BUG DESCRIPTION

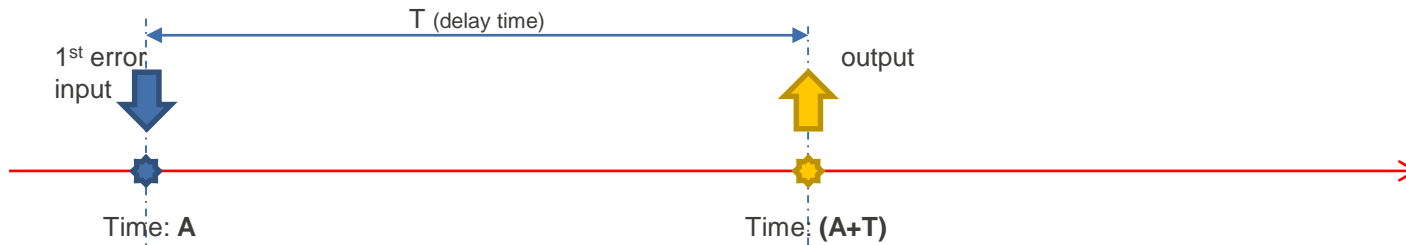
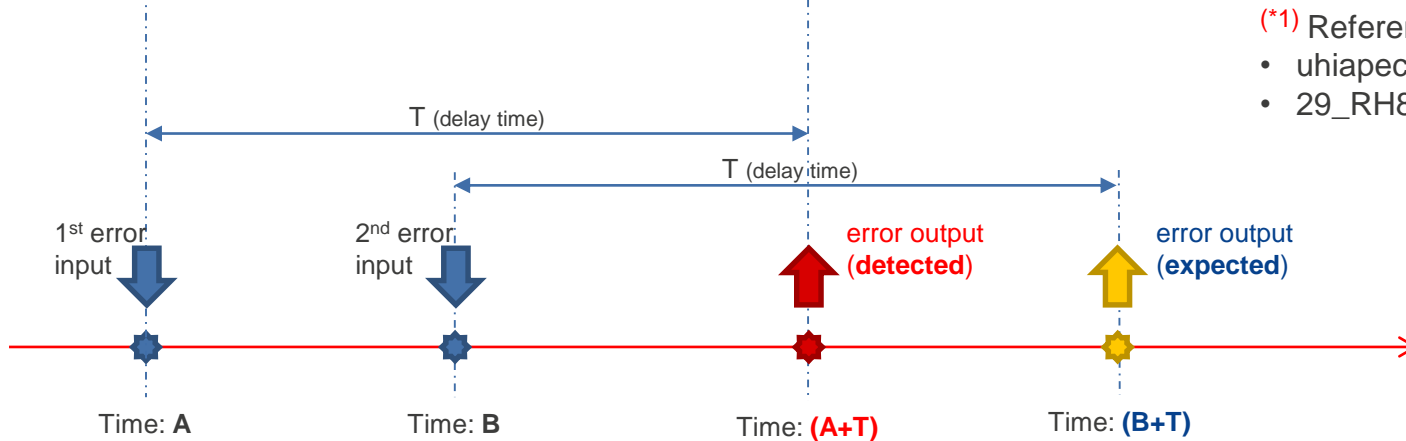
- ❑ After an error input asserts, after a delay time (configured by ECMDTMCMP register), an error output is issued.

- ❑ If another error input asserts during the delay time of the first error input, the delay time should be reset to 0 and count again^(*), but it is not reset and the delay time is shorter than expected.
